FLIGHT READINESS STATEMENT STS-70/ET-71 AND STS-69/ET-72 Δ EXTERNAL TANK PROJECT REVIEW

EXTERNAL TANKS ET-71 AND ET-72, AS IDENTIFIED IN THE EXTERNAL TANK PROJECT DELTA FLIGHT READINESS REVIEW DATED JULY 7, 1995, ARE CONSIDERED READY TO SUPPORT FLIGHT UPON ACCEPTABLE DISPOSITION OF OPEN WORK AND/OR OPEN ACTIONS.

STS-69/ET-72 Flight Readiness Review

STS-70/ET-71 STS-69/ET-72 Flight Readiness Review

GO2 Forward Pressure Line Leak (CAPS P-078)

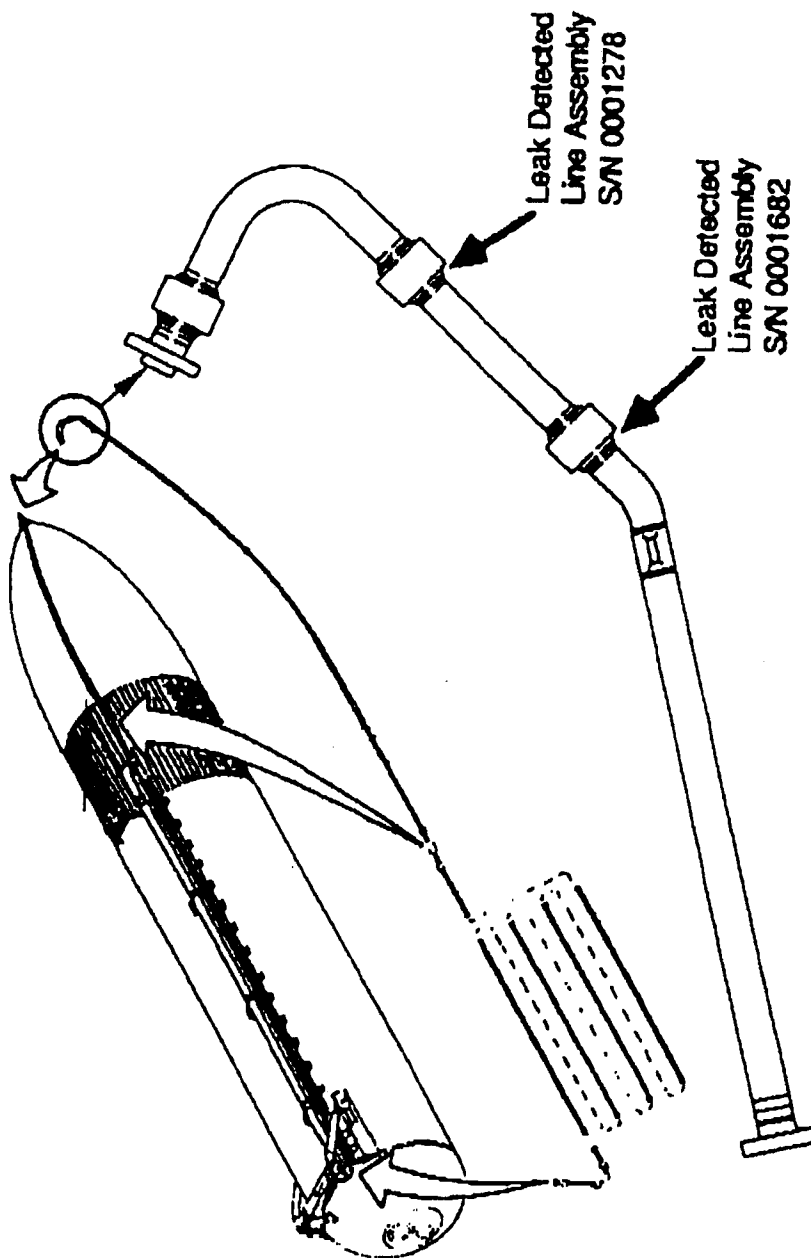
- Line S/N 0001278 at weld #4
 - Leaked during hydrostatic pressurization for the 600 psig deflection test
 - Leak subsequently verified by the GN2 leak test (noticeable at 25 psig)
 - Prior to deflection test, a drop of water was seen by operator following the 1500 psig proof test (source unknown)
 - Leak caused by a 0.030" long x 0.003" wide crack
 - Critical flaw size for weld #4 is 1.76"
 - Crack not detectable by X-ray and smaller than Probability of Detection (POD) for penetrant inspection
- Line S/N 0001682 at weld #6
 - Leaked during the 1500 psig proof test
 - Leak confirmed by a second 1500 psig proof test
 - Leak caused by a 0.025" long crack (unable to determine width)
 - Critical flaw size for weld #6 is 1.76"
 - Crack smaller than Probability of Detection (POD) for penetrant inspection

Pending investigation results

Pending investigation results

- ET-71 and up - All units successfully passed ATP
- ATP is designed to catch this type of failure

GO2 Pressure Line Leak (CAPS P-U/8)

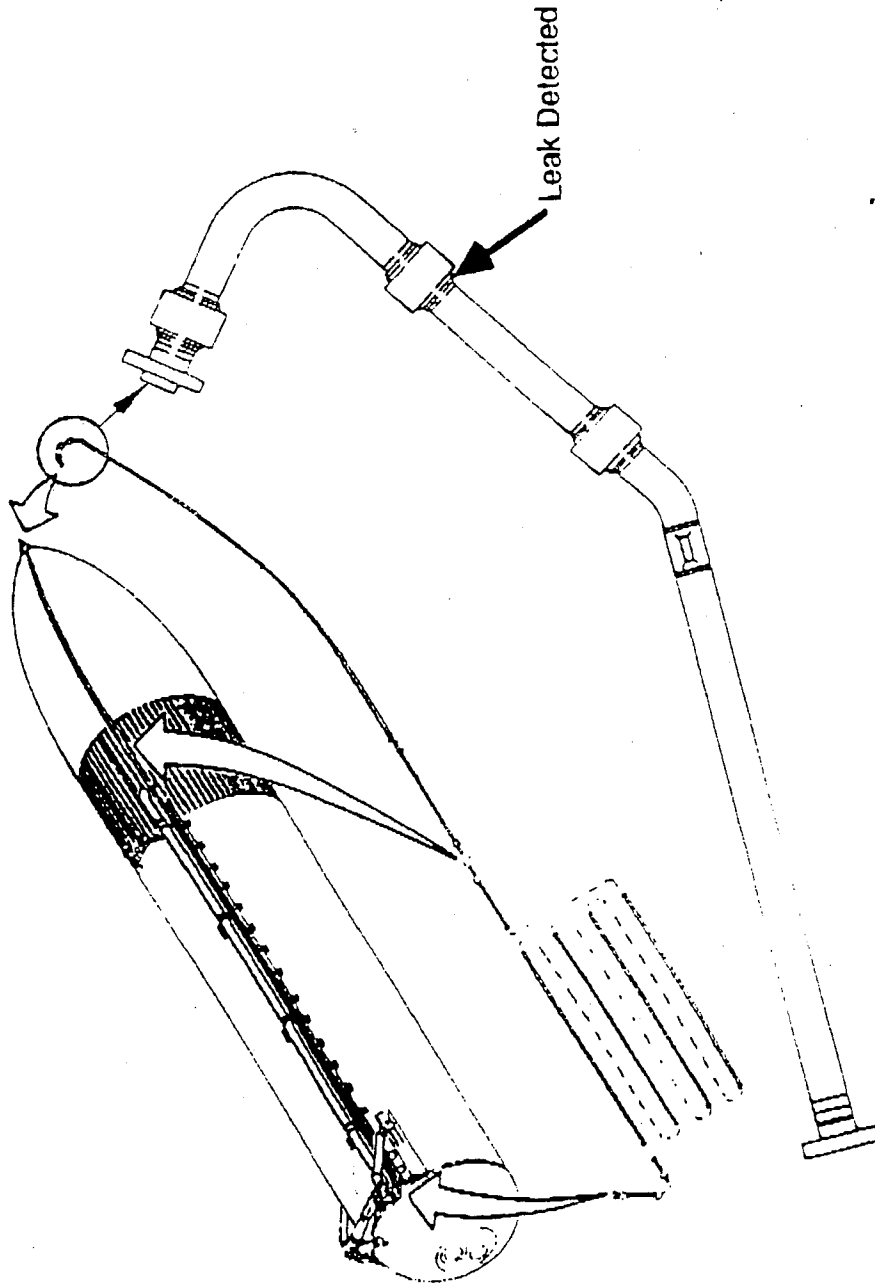
- GO2 forward pressure line leak detected during ATP

- Pressure line assembly tests:
 - 1500 psig hydrostatic proof test
- Deflection tests
 - Two motions unpressurized
 - Two motions with line hydrostatically pressurized to 600 psig
- Line is dried and leak tested using GN2
- Initial proof test resulted in a drop of H2O viewed on weld #4
- Leak was confirmed during pressurization for deflection testing

- ET-71 and up - All units successfully passed ATP

- ATP is designed to catch this type of failure
